Technical design note

Project name	Himley Village, Bicester - Reserved Matters Application		
Design note title	Response to LLFA Comments		
Document reference	27141-HYD-XX-XX-TN-C-0002		
Author	R Austin		
Revision	P01		
Date	22 March 2023	Approved	<input type="checkbox"/>

The following Technical Note is to be read in response to LLFAs comments on the Reserved Matters application reference 23/00207/DISC regarding the surface water drainage strategy for the Proposed Himley Village development site.

TITLE MIDDLETON STONEY ROAD, MAIN SPINE ROAD JUNCTION. PROPOSED DRAINAGE SHEET 1	
HYDROCK PROJECT NO. C-27141-C	SCALE @ A2 1 : 500
STATUS DESCRIPTION INFORMATION	STATUS S2
DRAWING NO. (PROJECT CODE-ORIGINATOR-ZONE-LEVEL-TYPE-ROLE-NUMBER) 27141-HYD-XX-XX-DR-C-0001	REVISION P01

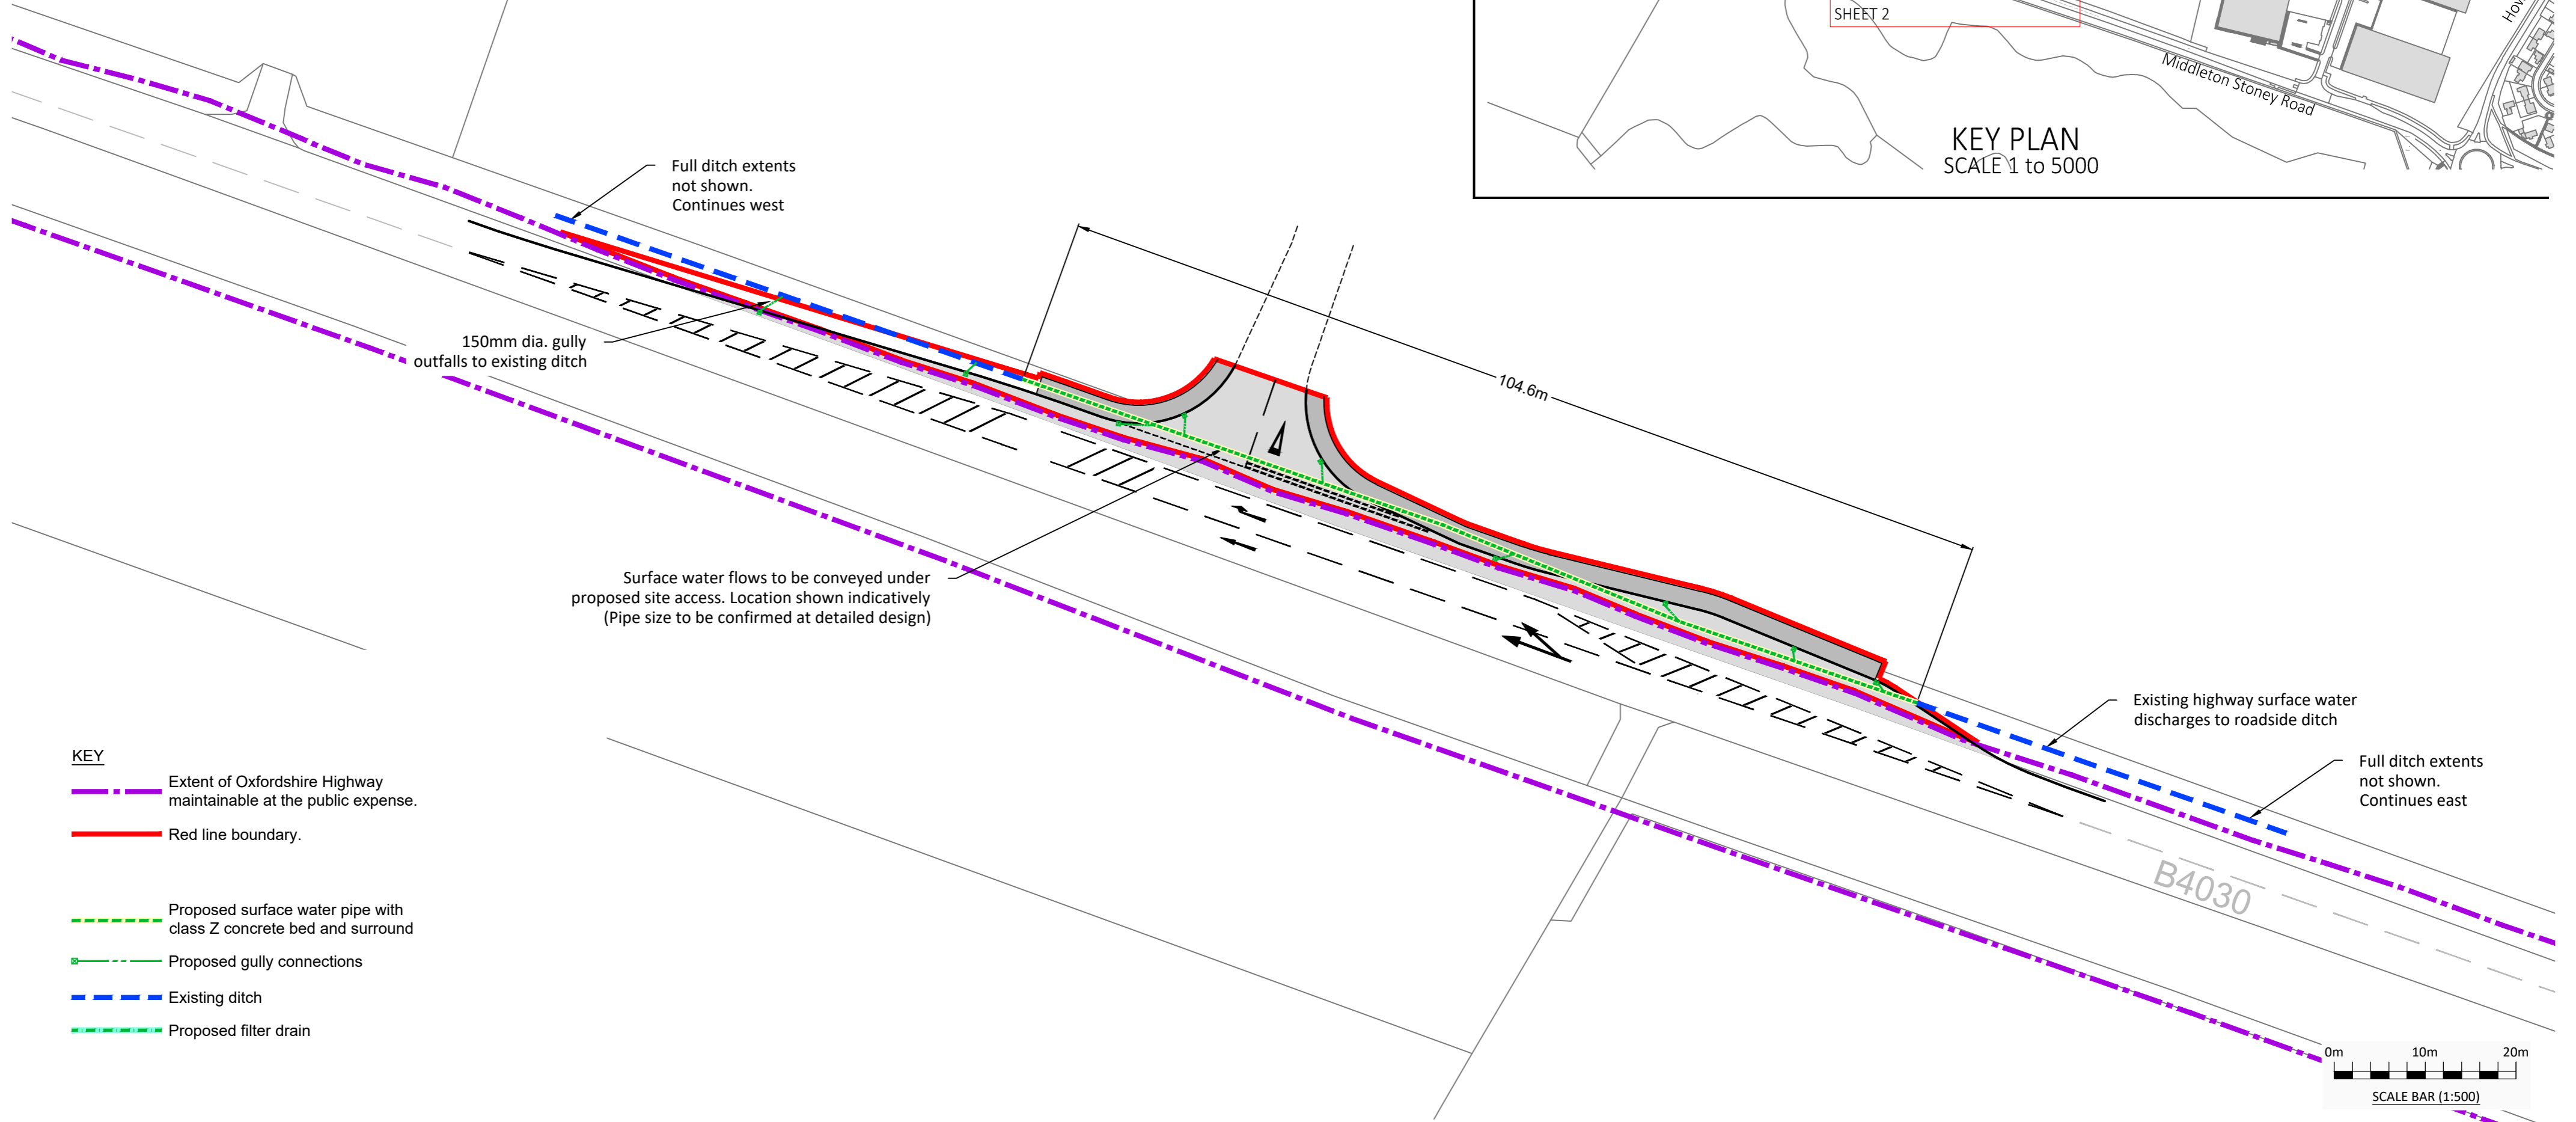
Discharge rates not provided on a drainage plan for each outfall location. Drainage plan not provided.

Drainage plan is required and sizing of SuDS features needs to be shown clearly. Invert and cover levels of all drainage to be showing.

Detailed drainage layout with pipe numbers

Detailed drainage plan not provided to illustrate the SuDS features

Drainage plans for each access are appended to this technical note, there is no specific network or "outfall" as such, each gully connect directly into the ditch adjacent (or culverted ditch if appropriate) and with each gully serving no more than 140m², a 20mm/hr rainfall event would see outfall rates from each gully at a maximum of 0.77l/s.

Drainage plans for each access are appended to this technical note, there are no specific SuDS features in this application which is solely for 2x highway access points. The only drainage apparatus proposed are gulleys with no distinct cover or invert level.

Drainage plans for each access are appended to this technical not, there are no pipe numbers as there are no networks, the access locations are served only by individual gulley connections.

Drainage plans for each access are appended to this technical note, there are no specific SuDS features in this application which is solely for 2x highway access points, the ditches proposed for use are existing.
